September 20, 2013

Reference:  
Fire Damage Observation  
418-420 Fore St.  
Portland, Maine

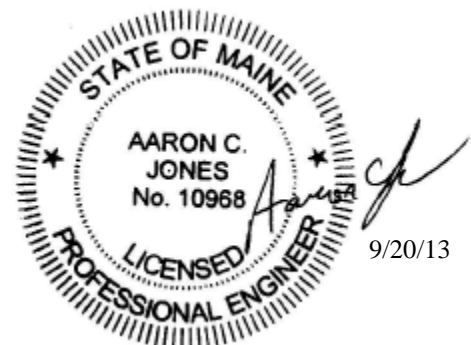
It appears that the structural damage from the fire was localized to the first floor and its supports. The floor here should be shored prior to any work/access. Though, in order to begin shoring work, an access hole needs to be cut in the 1<sup>st</sup> floor to avoid any walking on the unsupported framing.

Once, safe access is achieved the floor framing is to be shored and repaired/replaced as needed in a linear fashion working towards the Fore St. side of the building. The work should proceed as if it were a mining operation.
